1 April 2015

McKenzie Group Consulting Planning
(NSW) Pty Ltd
ACN: 146 035 707
Level 6, 189 Kent St, Sydney NSW 2000
Tel: 02 8298 6800 Fax: 02 8298 6899
email@mckenzie-group.com.au

Section 96(2) Modification Application (SSD 6078) – Oakdale Central, Horsley Park (Lot 21 in Deposited Plan 1173181)

Figure 1: Approved Layout – Lot 2B

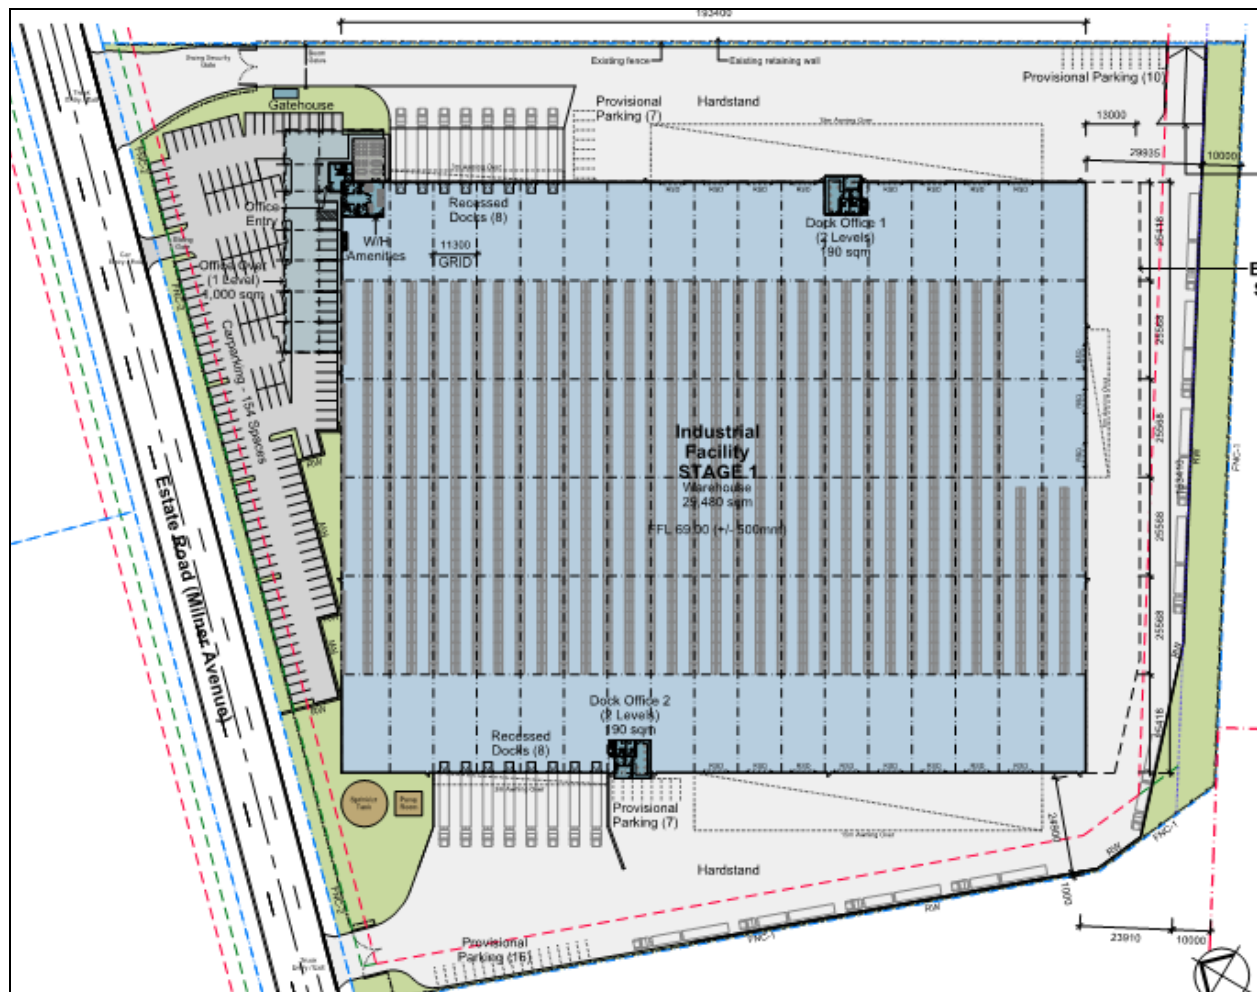
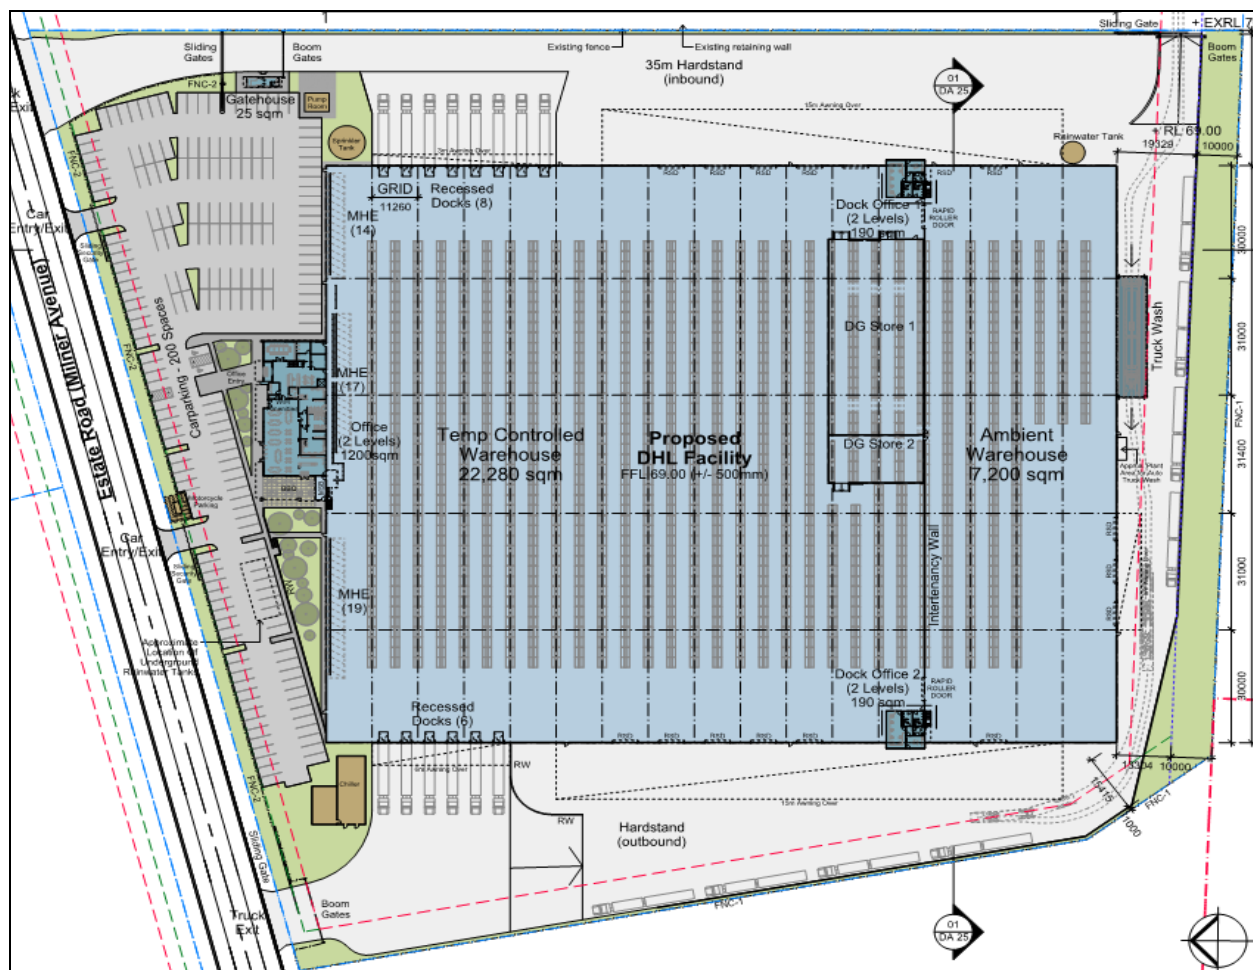
- Building Area reduced from 33,025sqm to 31,080sqm.
- Building changes to a temperature controlled facility.
- Dangerous Goods (DGs) store added.
- Warehouse roller shutter locations adjusted.
- Warehouse racking revised.
- Electrical Kiosk substation added.
- Motorcycle parking added.
- Chiller Room added.
- MSB Room added to Outdoor Area.
- Underground water rainwater tank added to car park.
- Retaining walls and stair added to landscaped area in car park.
- Plant Room for Truck Wash added.
- Rainwater tank for truck wash added.
- Office replanned and relocated to centre of building.
- Total parking increased to 200 spaces, provisional spaces deleted.
- Sprinkler tank and pump room relocated.

The approved and modified scheme for warehouse 2B is provided in the below figures.
